Service Letter: 452

Title: Relocation of Cowl Fastener

Models: 8KCAB (AEIO-390-A1B6 engine, serial numbers 1179-2018 and prior);  
8GCBC (IO-390-A1B6 engine, serial numbers 596-2019 and prior);  
When seven screws secure lower cowl to noseowl

**Figure 1, Fastener Location**

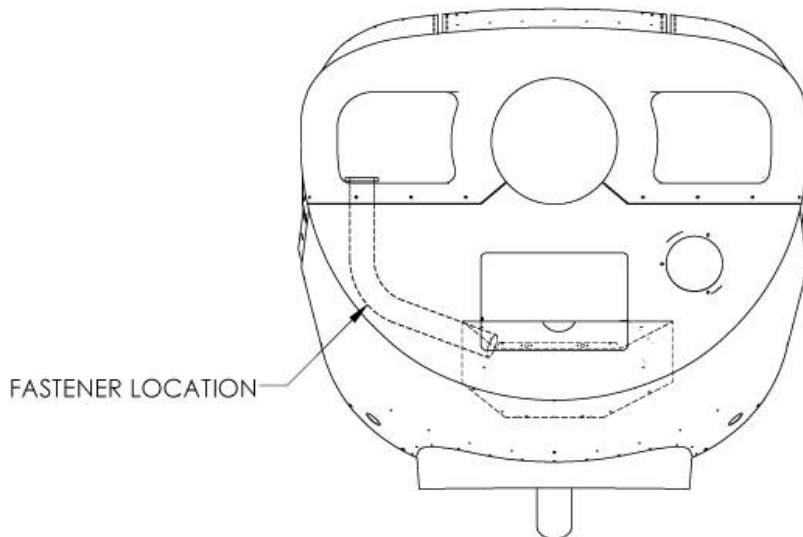
1. Open left side cowl door (4 camlocks).
2. Observe clearance between cowl fastener and #1 exhaust tube at location shown in Figure 1 (typical clearance is .25 inch with AN526C1032R6 screw). Visually inspect #1 exhaust tube for indications of damage (wear/chafing from screw or nutplate). It may be necessary to use a mirror to view the front of the exhaust tube with the cowling installed.

3. If damage to exhaust is noted replace 3-1791 exhaust tube with serviceable part per AMM. Modify to the cowl fastener location to prevent abrasion. If wear is not noted and clearance is adequate; inspect at next 100-hour or annual inspection.
4. Close left side cowl door (4 camlocks).

Figure 2, New Fastener Locations

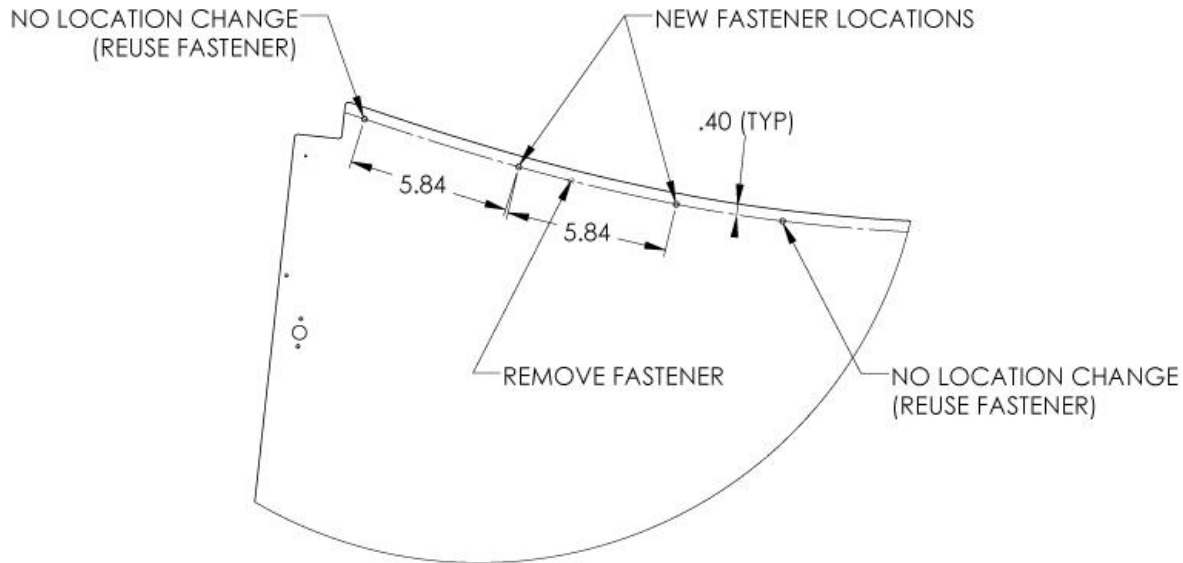
Description: Wear of the #1 cylinder exhaust tube by a cowl fastener has been reported on several aircraft. This service letter provides for inspection of the exhaust tube, replacement of the tube (if damaged), and relocation of the cowl fastener (if exhaust tube is worn). If modification of the lower cowl is not desirable it may be replaced with a later revision part having nine evenly spaced holes.

1. Mark fastener locations as shown in figure 2. Hole spacing is 5.84 inches measured from the top right fastener; position holes .40 inches from the front edge of the lower cowl.

2. Drill Ø.191 hole (2 places) through lower cowl and nosebowl (right side of cowl only).
3. Open left and right cowl doors (8 camlocks).
4. Remove cable ties securing landing light harness to lower cowl (2 ties, left side).

7. Enlarge fastener hole in nosebowl with Ø.25 drill. Position MS21059L3 nutplates (2 required); drill Ø.098 rivet holes and secure with AD32BS rivets (4 required).
